Consumers Power Company
Big Rock Point Plant
Docket 50-155

PROPOSED TECHNICAL SPECIFICATION PAGE CHANGES

January 10, 1990

EVALUATION OF GENERIC LETTER 88-11
ON BIG ROCK POINT TEMPERATURE/PRESSURE LIMITATIONS

FLANGE RT_{NDT} = 40 °F HYDROSTATIC TEST CONDITION

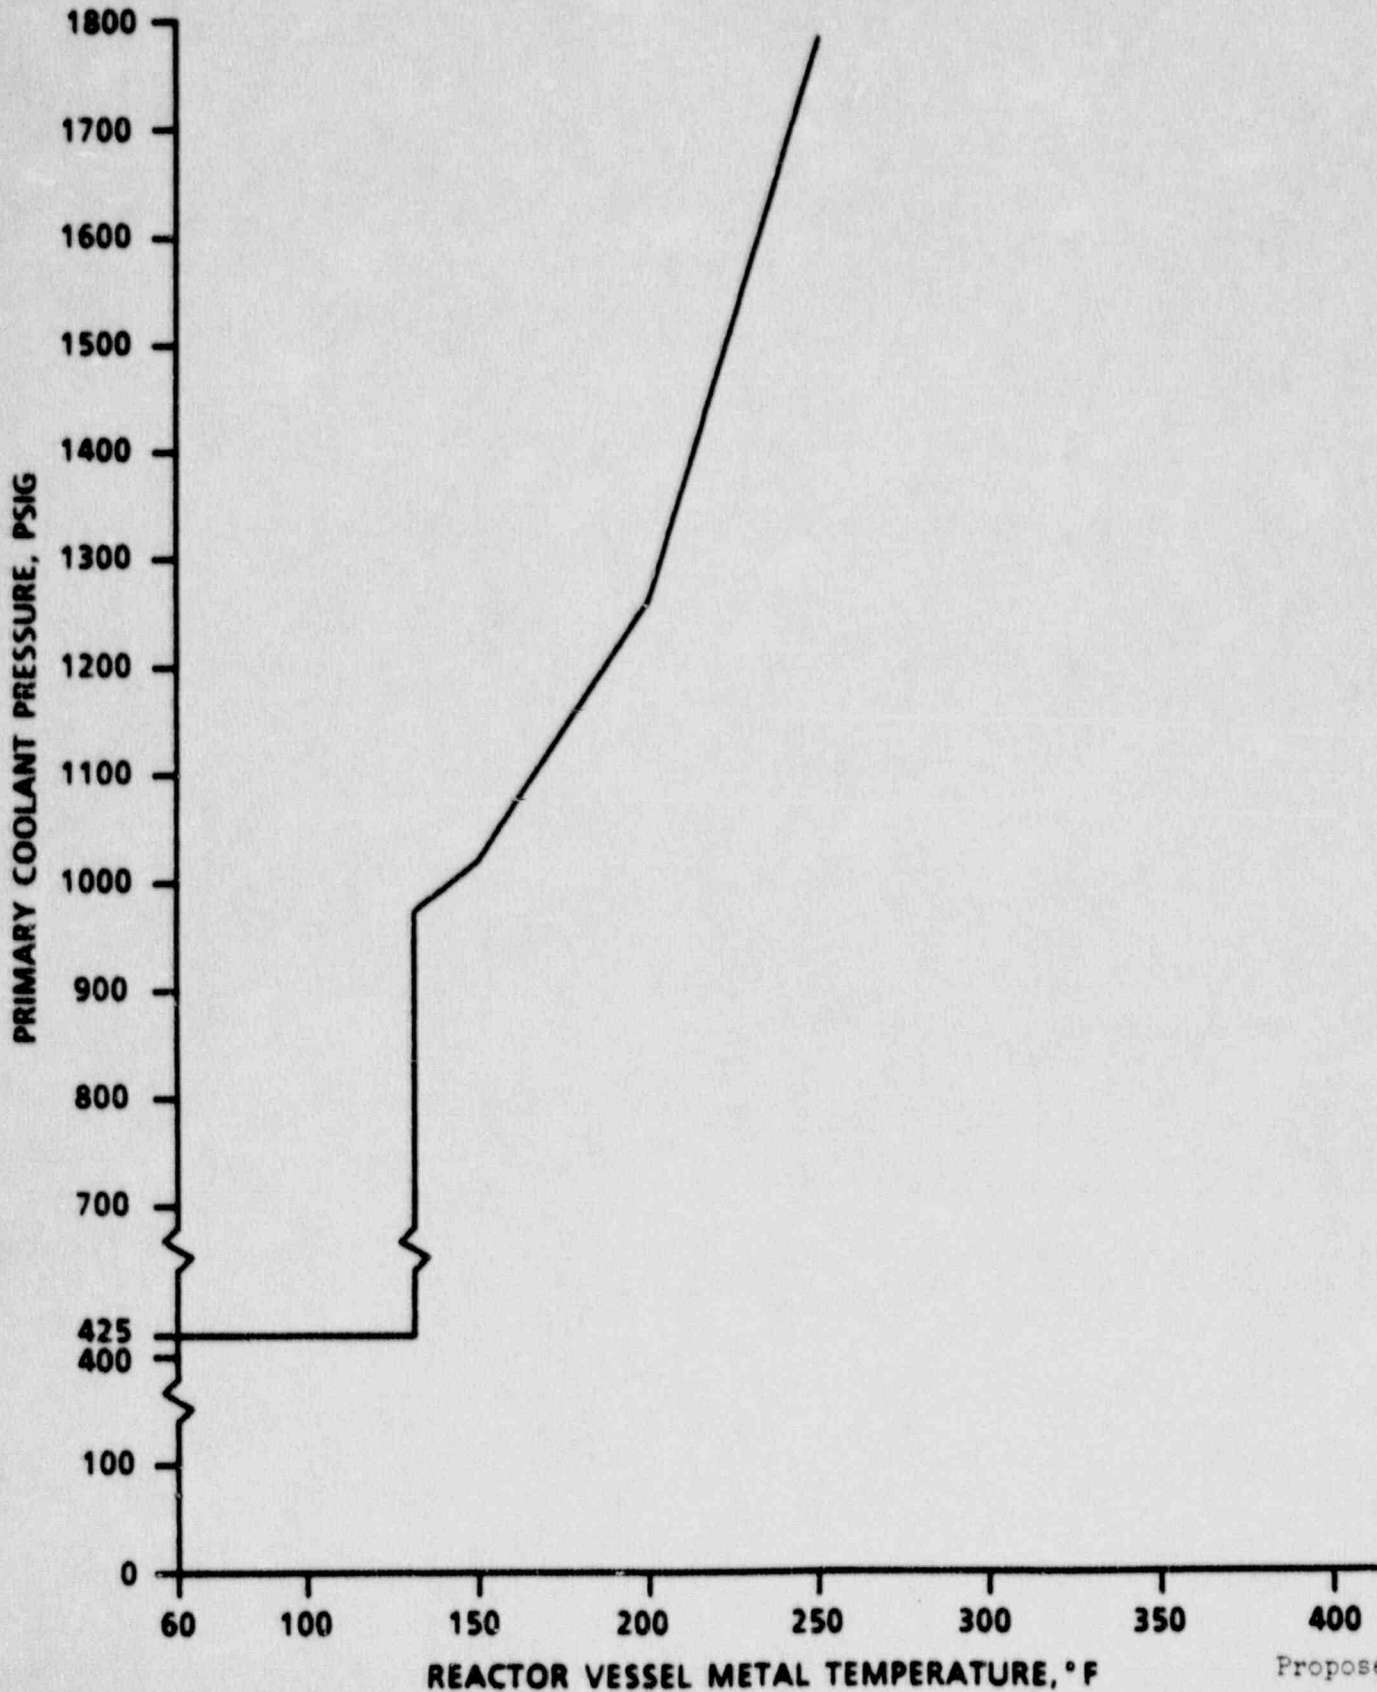
3. Reactor vessel pressure shall be limited in accordance with Figures 4.1, (a), (b) and (c).
4. The reactor shall not be made critical, with the exception of physic testing, at temperatures below the criticality limit shown on Figures 4.1(b) and 4.1(c).

**BIG ROCK POINT NUCLEAR PLANT:
PRESSURE-TEMPERATURE LIMITS EFFECTIVE TO 18 EFFECTIVE
FULL POWER YEARS**

**HYDROTEST TEMPERATURE: 1475 PSIG @ 224 °F
1525 PSIG @ 229 °F**

FLANGE $RT_{NDT} = 40^\circ F$ COOLDOWN CONDITION

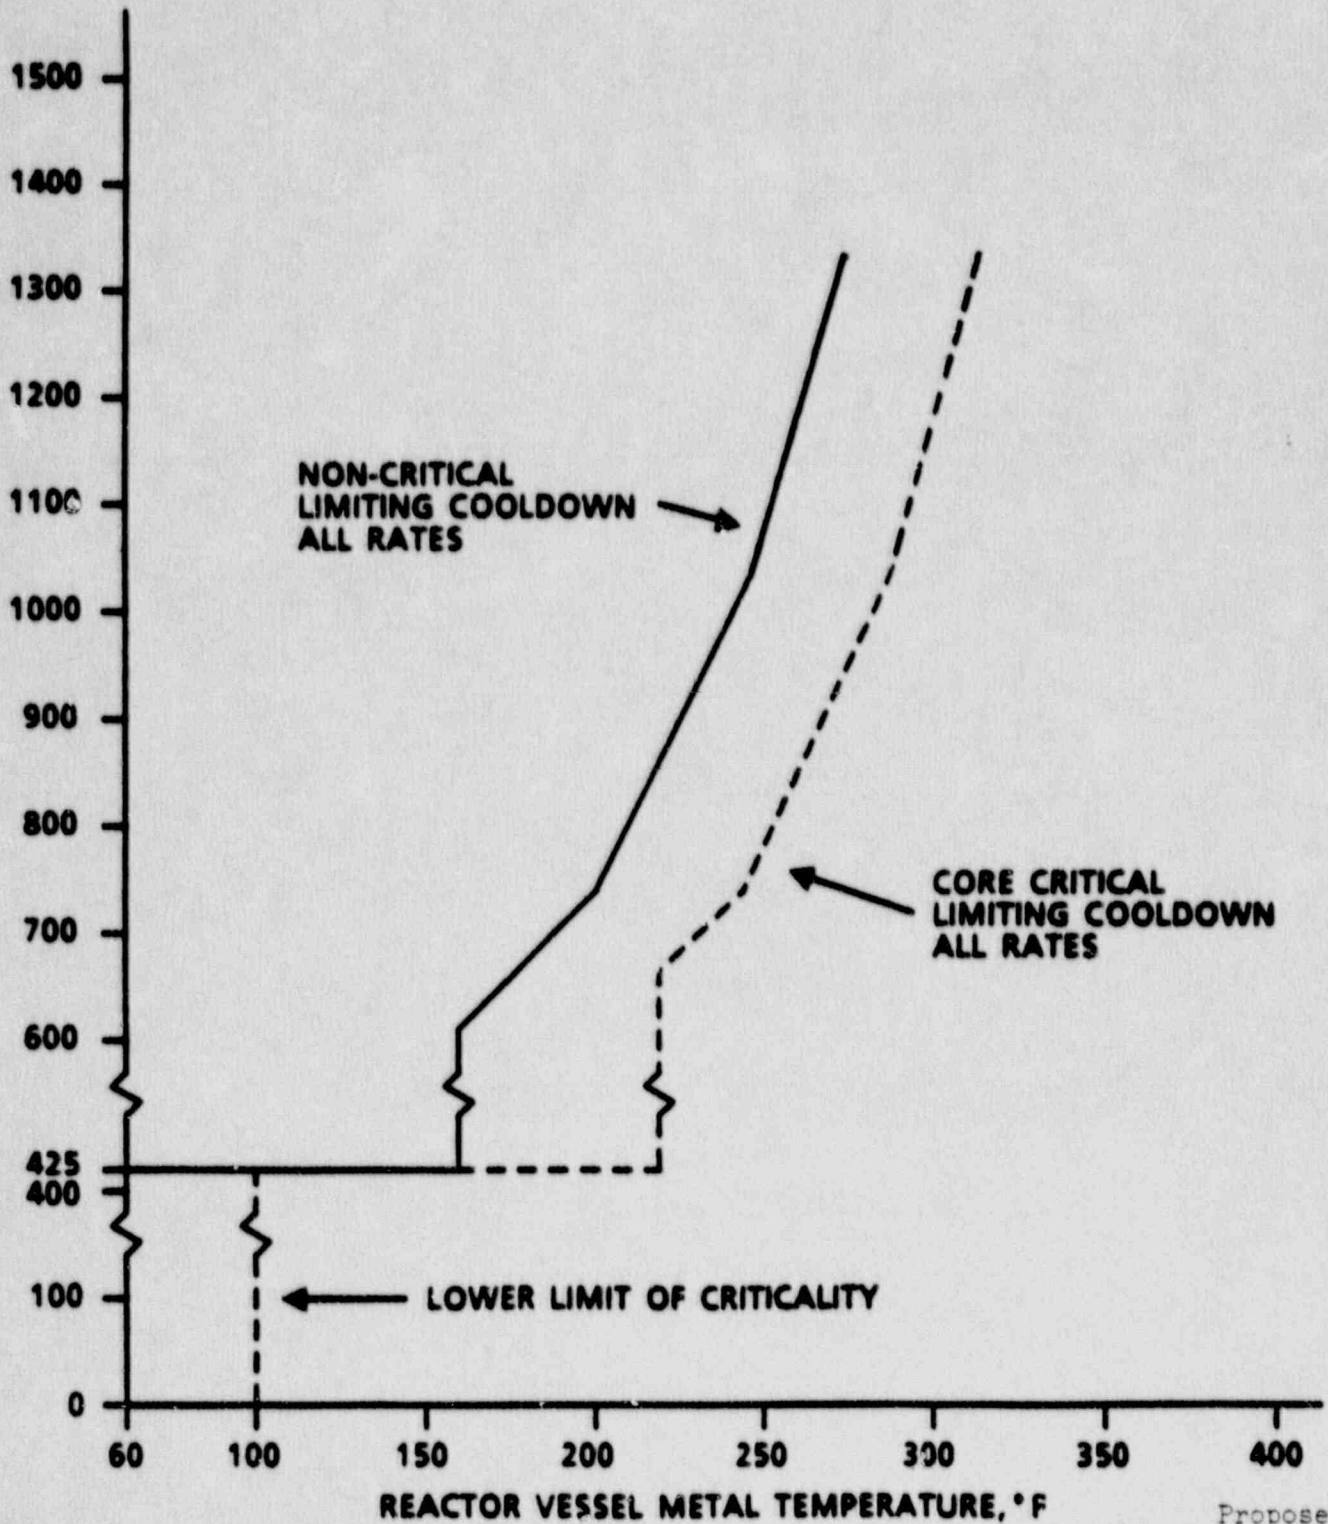
**BIG ROCK POINT NUCLEAR PLANT:
PRESSURE-TEMPERATURE LIMITS EFFECTIVE TO 18 EFFECTIVE
FULL POWER YEARS**

**SOLID LINES ARE NON-CRITICAL CONDITION
DASHED LINES ARE CRITICAL CONDITION**

FLANGE RT_{NDT} = 40°F HEATUP CONDITION

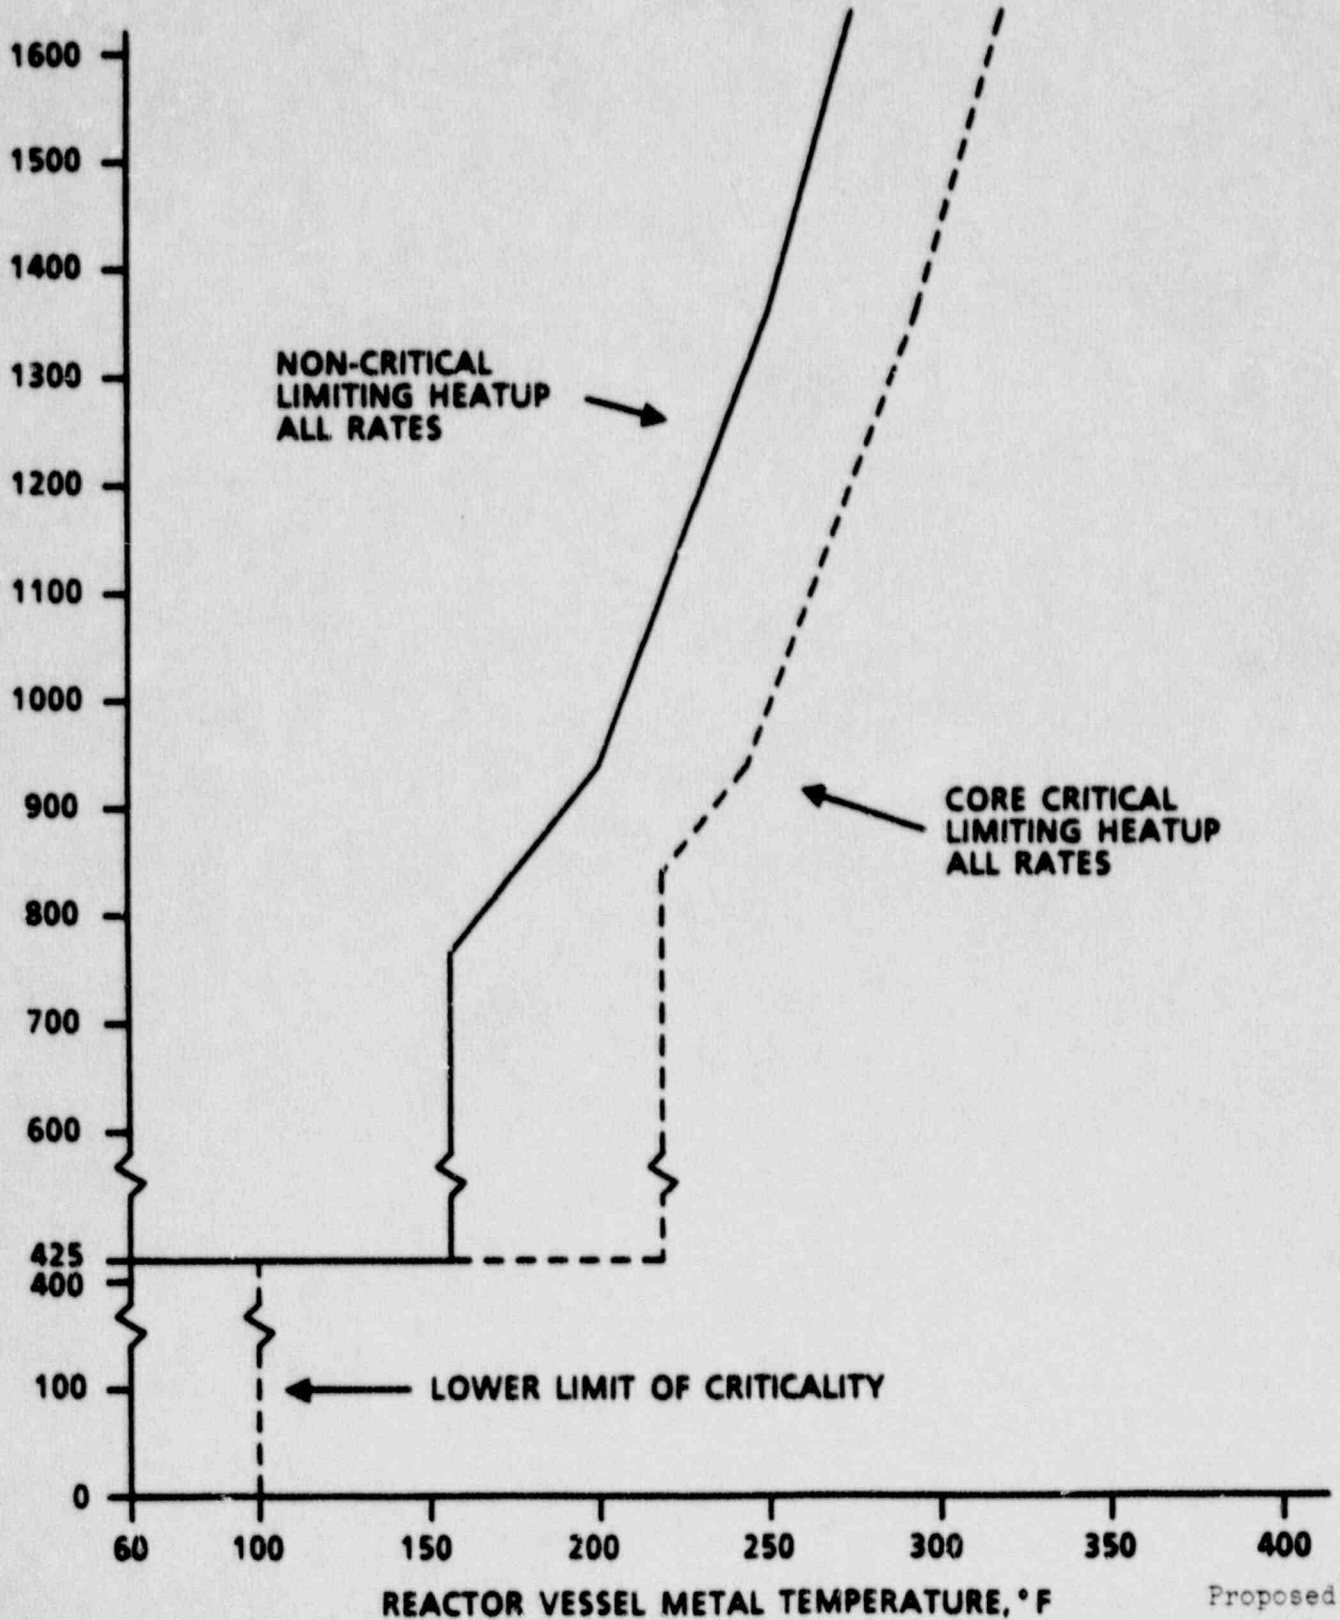
**BIG ROCK POINT NUCLEAR PLANT:
PRESSURE-TEMPERATURE LIMITS EFFECTIVE TO 18 EFFECTIVE
FULL POWER YEARS**

**SOLID LINES ARE NON-CRITICAL CONDITION
DASHED LINES ARE CRITICAL CONDITION**
